**Response to NRC Generic Request for Additional Information Regarding
Relaxed Axial Offset Control, R.E. Ginna Nuclear Power Plant (TAC No.
MC6867)**

**RESPONSE TO NRC REQUEST FOR ADDITIONAL INFORMATION
REGARDING RELAXED AXIAL OFFSET CONTROL, R.E. GINNA
NUCLEAR POWER PLANT**

Figure 1 (F_Q Results from Most Limiting Representative LP)

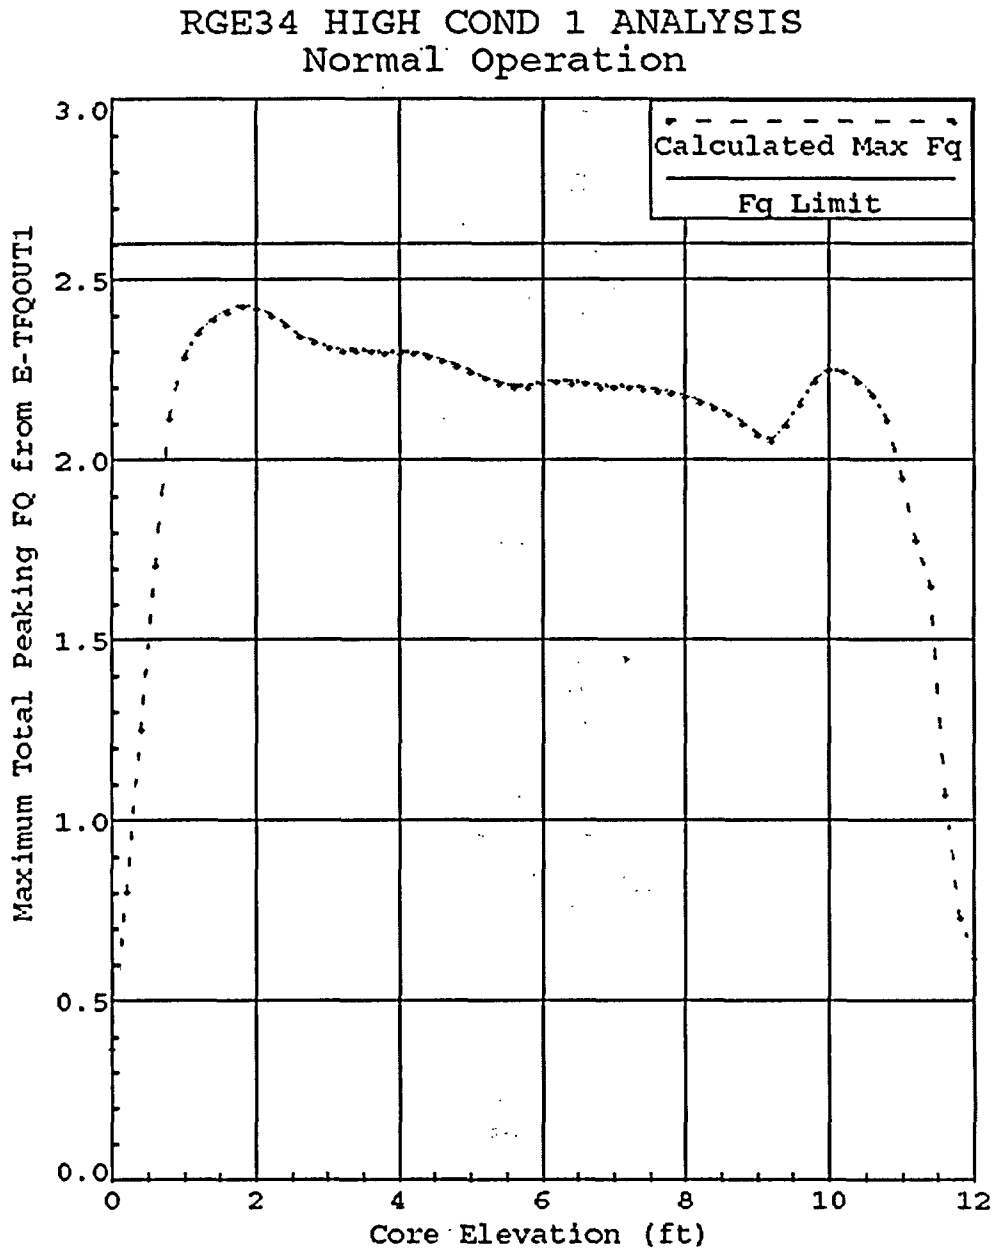
Provide the results of the F_Q analysis (i.e., the permissible F_Q and the $W(Z)$ function).

As described in the response to RAI #1, the analysis performed for Ginna was based on representative uprated loading patterns, and a specific reload analysis will be performed for each reload to check the applicable limits. The requested results from the most limiting representative loading pattern studied for Ginna are shown in Figures 1 and 2. These results correspond to the typical AFD band limits identified in the response to RAI #1. The maximum transient F_Q result for the limiting representative cycle was 2.432, compared to a LOCA limit of 2.60. These results only confirm the viability of the methodology and should not be used as a defining basis for NRC approval. As described in the 29 April 2005 application, the actual determination of the permissible F_Q and the $W(Z)$ values is performed for each reload cycle.

The cycle-specific F_Q analysis will be performed for Cycle 33 based on the power level, operating temperatures, actual loading pattern details, fuel characteristics and other conditions associated with the reload cycle. These results will be confirmed as part of the reload evaluation process to ensure that the applicable safety criteria will be met. This confirmation process is consistent with the NRC-approved reload methodology of WCAP-9272-P-A (approved via NRC letter from Cecil O. Thomas (NRC) to E. P. Rahe (W), "ACCEPTANCE FOR REFERENCING OF LICENSING TOPICAL REPORT WCAP-9272(P)/9273(NP) WESTINGHOUSE RELOAD SAFETY EVALUATION METHODOLOGY," May 28, 1985) and the conditions set forth in 10 CFR 50.59.
